# Old Design

LAYER 'Elektroden\_Kanal\_unten'

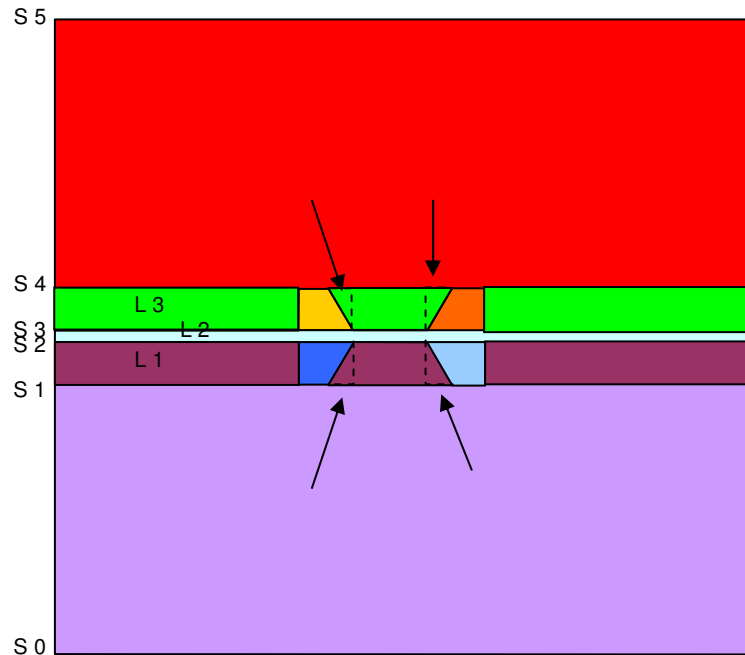
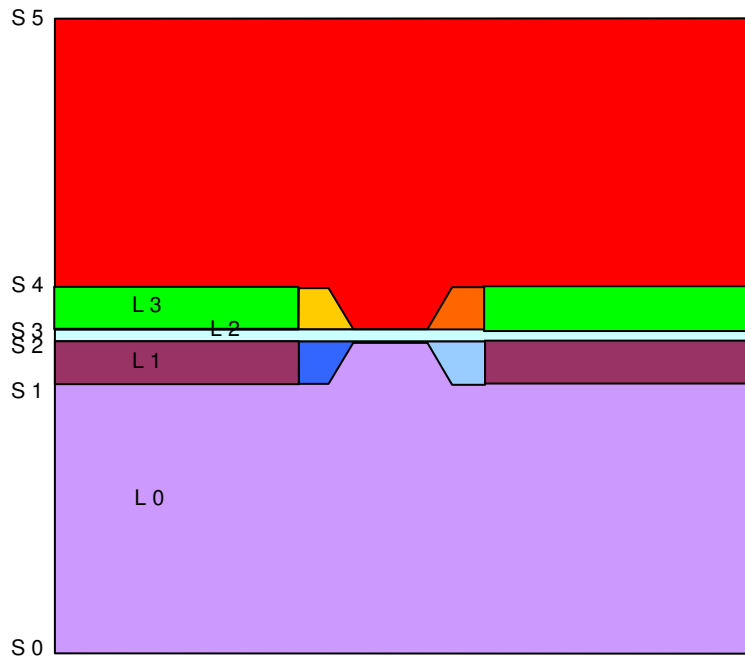
The cross section shape of the bar in the middle should become the shape of a trapezoid.

Adding two slopes on each side of the two existing bars and keep them in Layer 1 (L1)

Trying to use surface 1 (S1) to shape a trapezoid cross-section of the two bars on layer 0 (L0)
